SECTION 009113 – ADDENDUM FIVE

- 1.1 PROJECT INFORMATION
 - A. Project Name: 22034.03 Meridian High School Baseball/Softball
 - B. Owner: Meridian Public School District, 1019 25th Avenue, Meridian, MS 38391

- E. Date of Addendum Five: 28 April 2023
- 1.2 NOTICE TO BIDDERS
 - A. This Addendum is issued to all registered plan holders pursuant to the Instructions to Bidders and Conditions of the Contract. This Addendum serves to clarify, revise, and supersede information in the Project Manual, Drawings, and previously issued Addenda. Portions of the Addendum affecting the Contract Documents will be incorporated into the Contract by enumeration of the Addendum in the Owner/Contractor Agreement.

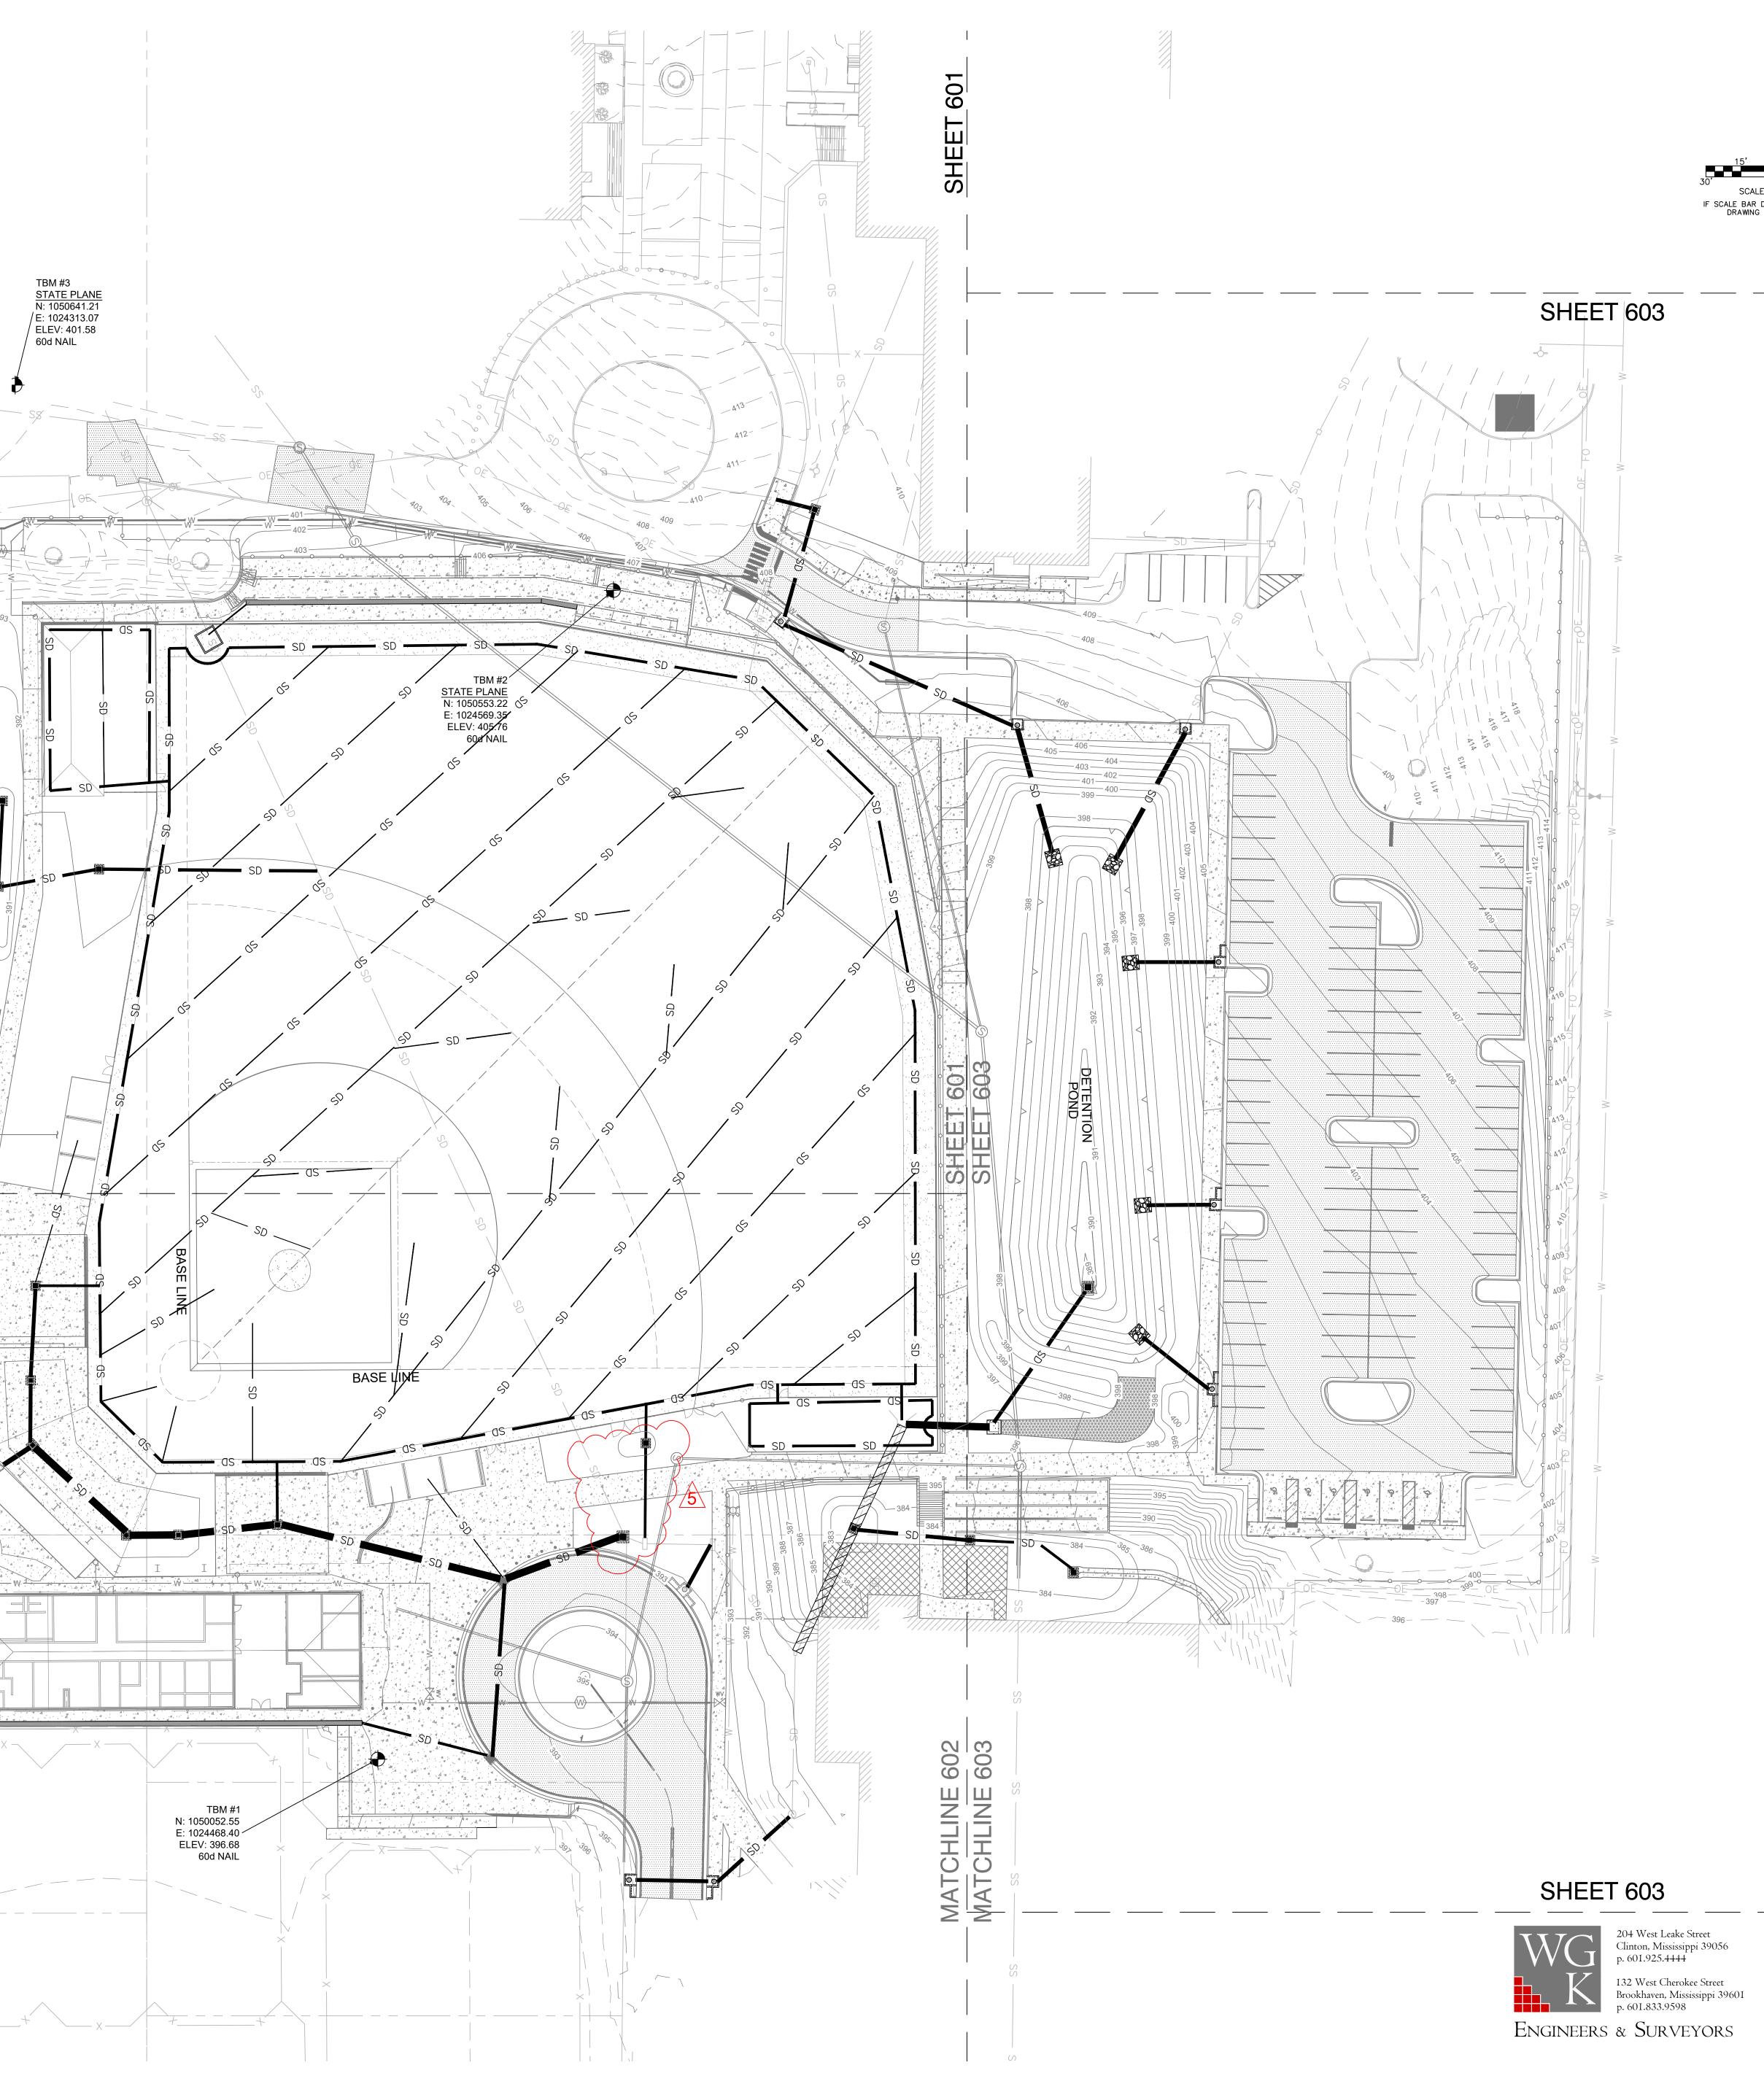
- 1. Drainage improvements shown on Sheets 600-603 are what is required of CONTRACTOR for the project's base bid. CONTRACTOR to include pricing within the base bid to complete 12,000 LBS of Undersealing to the existing 36" RCP, as described within the project specifications. This pricing should include costs to complete the work as a whole in place to include injection of polyurethane foam, surface injection (if required), camera work associate with location of joints needing undersealing, finished camera work, removal of excess foam from inside of pipe, and any other incidentals as related to the completion of this item of work. CONTRACTOR to provide unit pricing for Undersealing, per LB, that will be used to adjust the contract accordingly based on amount of foam needed.

- CONTRACTOR to provide pricing for a drainage alternate which includes the removal of the double run of 36" RCP and replacing with two new runs of 36" RCP drain pipe and associated tie-ins to existing and proposed drainage structures. Length of total 36" RCP to be installed is approximately 1,100 LF.
